**ARCHITECTURAL
REVIEW COMMITTEE**

ARCHITECTURAL REVIEW COMMITTEE MINUTES MAY 10, 2023

Strand Associates, Inc.® (Strand) has finished its review of the construction drawings and Storm Water & Erosion Control Calculations resubmittal for the Quest Interiors Development that were received from Excel Engineering, Inc. (Excel) on May 22, 2023, for conformance with the Town specifications and general engineering practices. Before construction may begin, the contractor shall submit all required permits for the development to the state, Wisconsin Department of Natural Resources, Town, and any other relevant agencies. New drawings, stormwater management plan and calculations, and a letter describing the revisions should be returned to Strand after the following concerns have been addressed. Excel's responses to Strand's original comments are *italicized* and Strand's most recent comments are in **bold**.

CIVIL LANDSCAPE AND RESTORATION PLAN

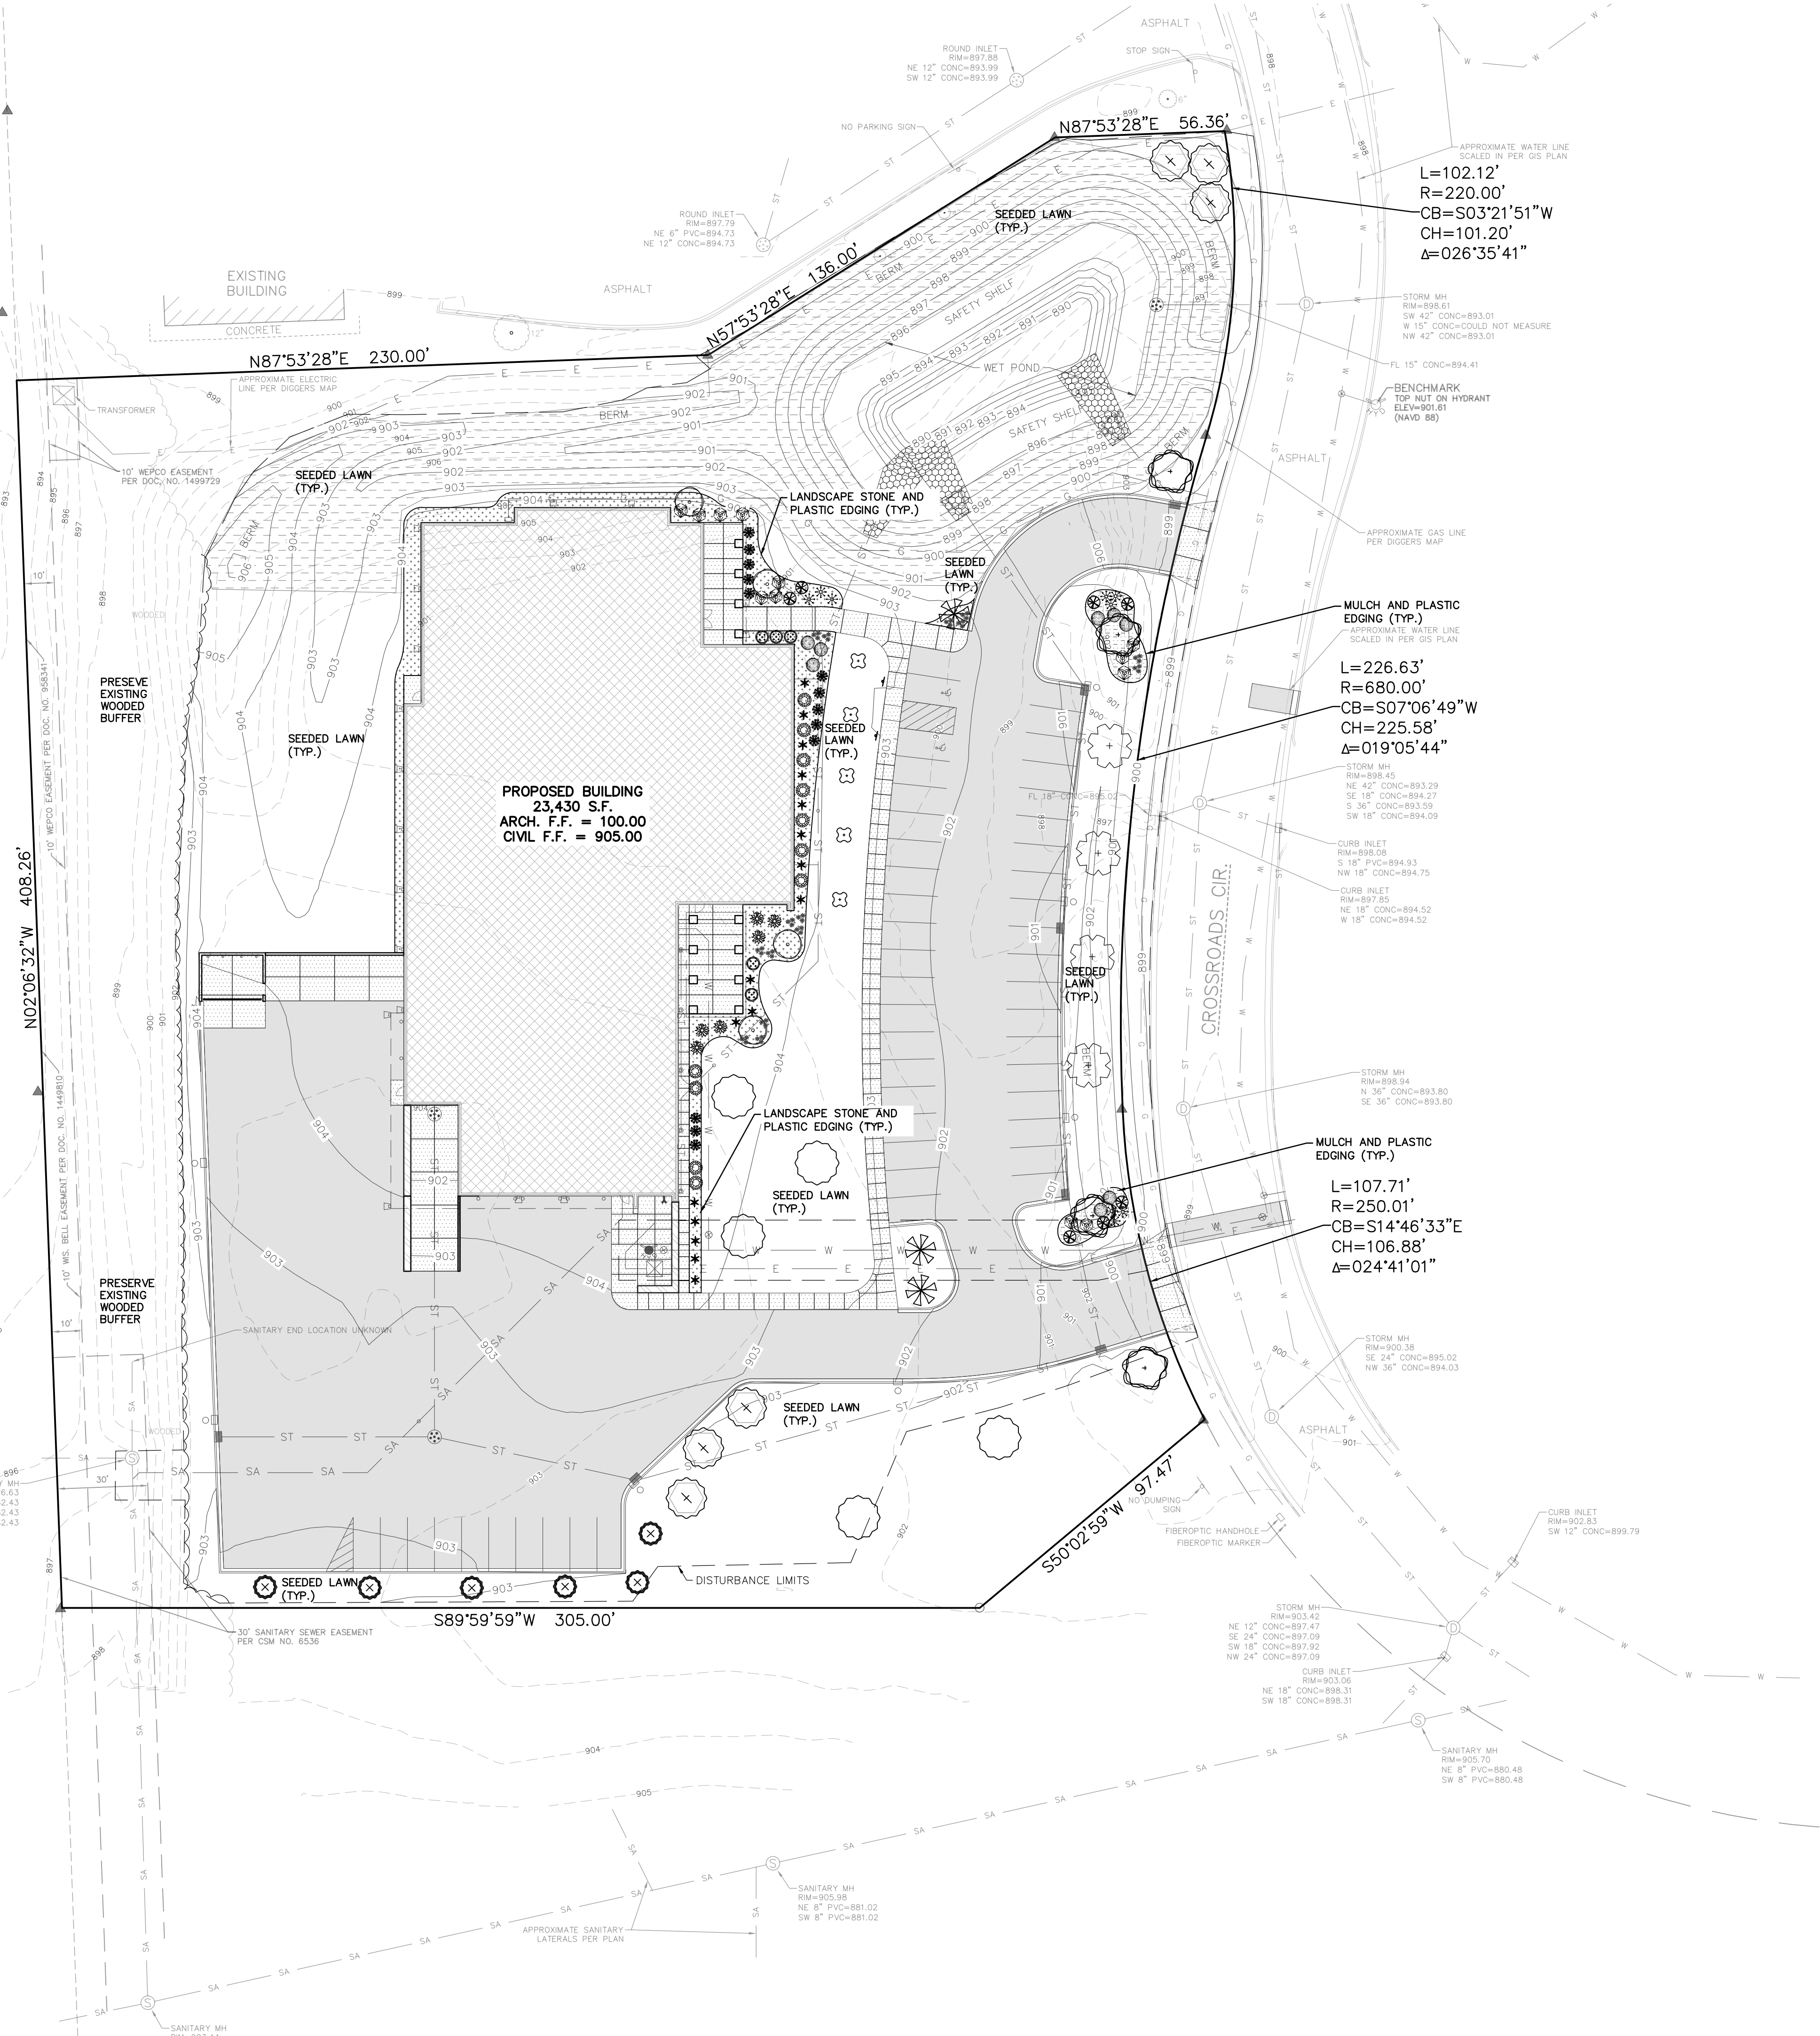
1. Strand's May 3, 2023, Comment—Please denote intended tree protection or woodland area protection provided on-site.

- b. Strand's May 3, 2023, Comment—Varieties of flowering pear (*Pyrus calleryana*) are regarded as potentially invasive. If acceptable, please explore potential replacements such as suitable varieties of flowering crabapple (*Malus* species) or redbud (*Cercis canadensis*).

Excel's May 22, 2023, Response—Plan notes are on C1.0 and C1.4 to provide intent of preservation of wooded area.

Strand's Current Response—Notes were reviewed and are adequate.

Excel's May 22, 2023, Response—The Jack pear species has been substituted with a flowering crabapple.
